State of West Virginia
 Request for Quotation
 04 - Audio/Video

Doc Description: ONE TIME PURCHASE AND COMPLETE INSTALLATION OF A CCTV SYSTEM

Doc Description: ADDENDUM #1 ONE TIME PURCHASE & COMPLETE INSTALL OF A CCTV

ADDENDUM #2 - TO PROVIDE ANSWERS TO QUESTIONS SUBMITTED BY VENDORS DURING THE SOLICITATION PROCESS, TO PROVIDE A COPY OF THE PRE-BID SIGN-IN SHEET, AND TO MODIFY THE CAMERA LOCATIONS AND PAYMENT SCHEDULE.

FIRST FLOOR

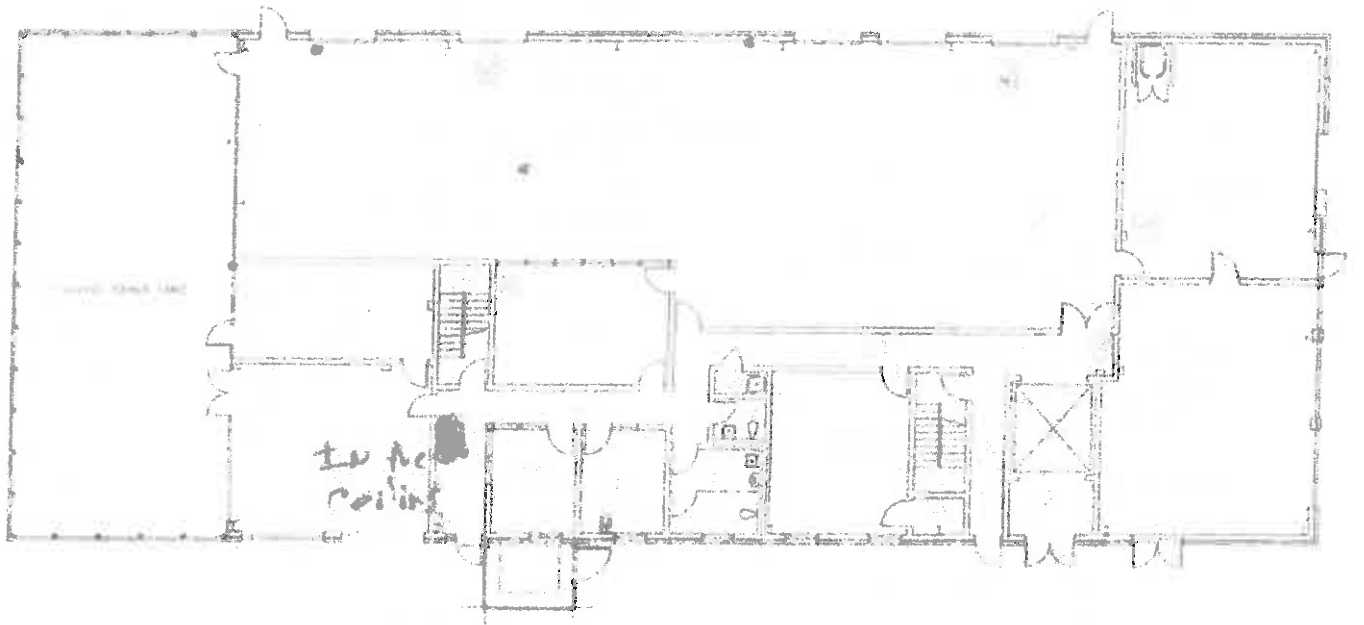
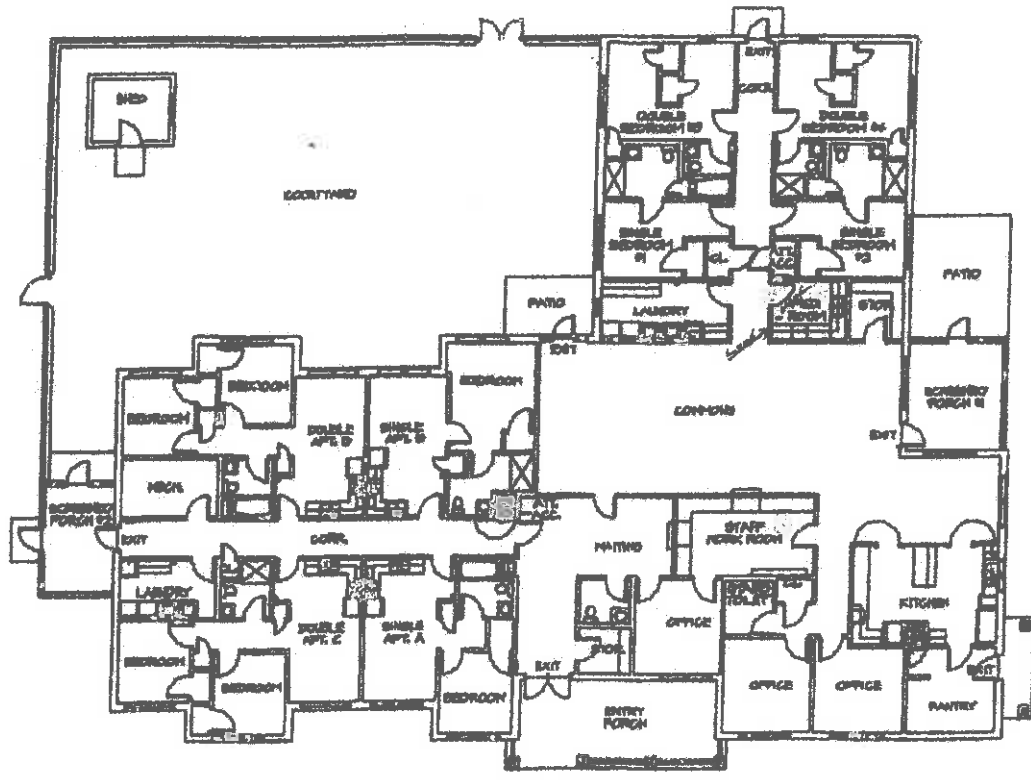
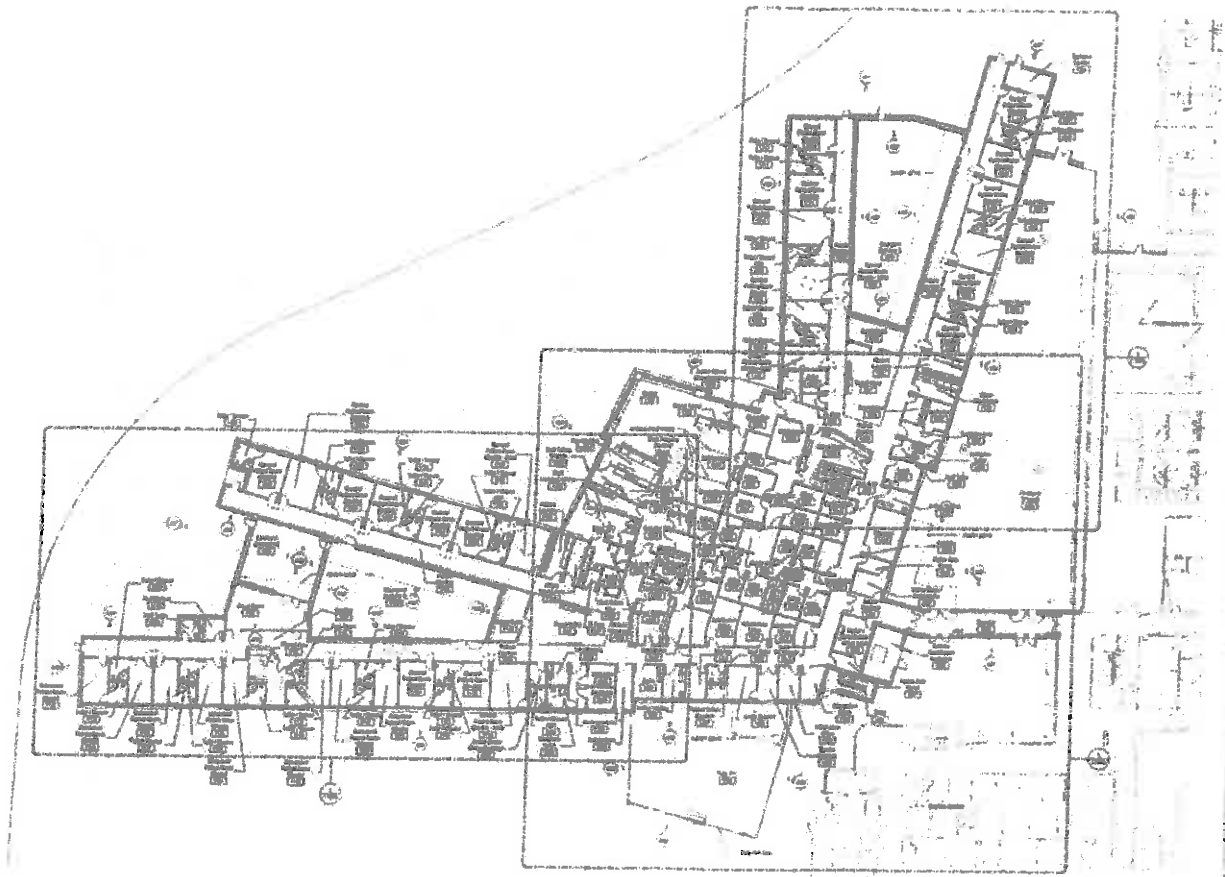
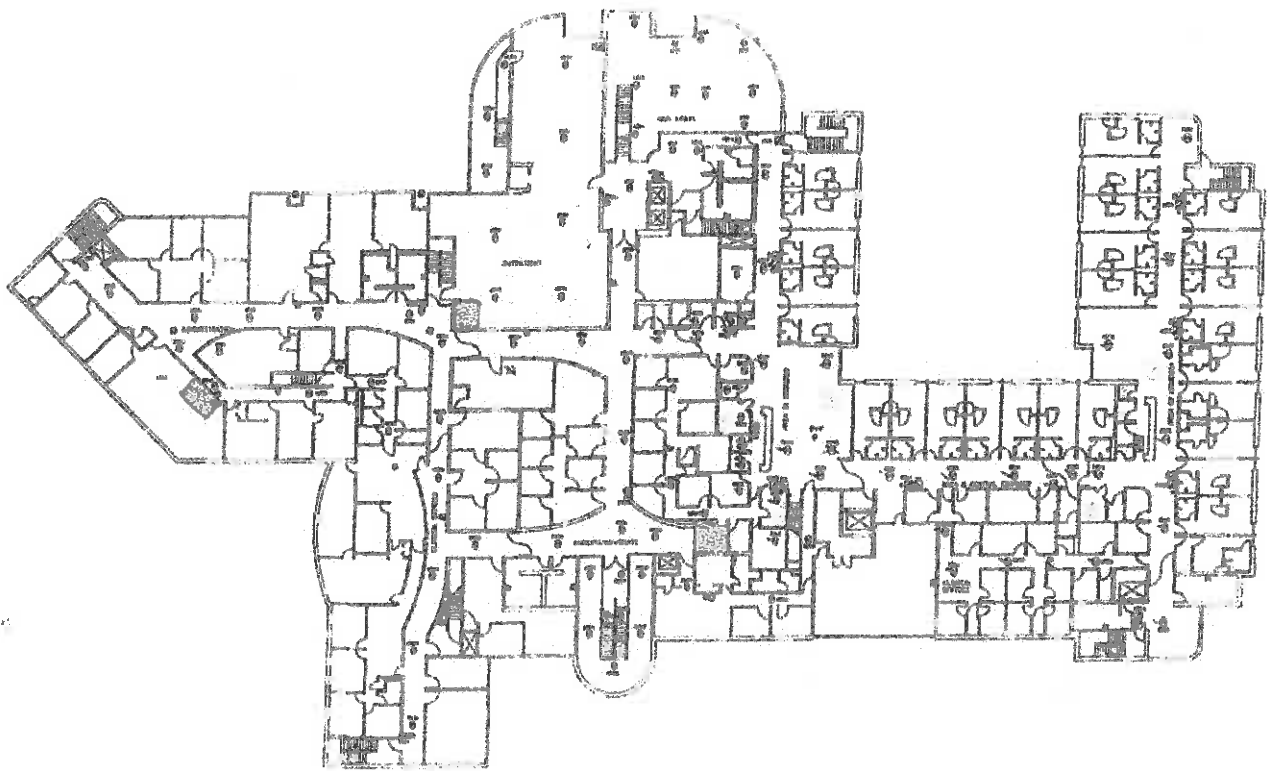
Description of Modification to Solicitation: To provide answers to questions submitted by vendors during the solicitation process, to provide a copy of the pre-bid sign-in sheet, and to modify the camera locations and payment schedule.

An "*" has been added beside the location on the camera location attachment.
